Forwarding these slides for discussion at the October 11, 2018, public meeting regarding LAR 18-026, Column Line 1 Wall Reinforcement Area Change.

LAR-18-026: Column Line 1 Wall Reinforcement Area Change

Column Line 1 Wall (Auxiliary Building @ El. 135'-3")

Figure 3H.5-3
[Typical Reinforcement in Wall on Column Line 1]*

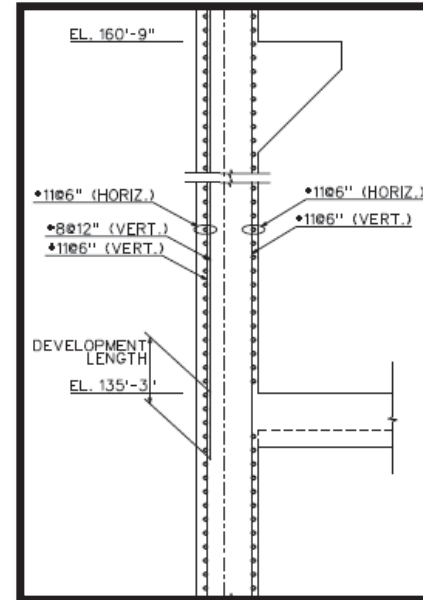
- Proposed change to rebar configuration
 - Development length of #8s @ 12" to begin at 135'-3"
 - Impacts provided area of reinforcement from 135'-3" through development length
- Plan to submit PAR concurrently
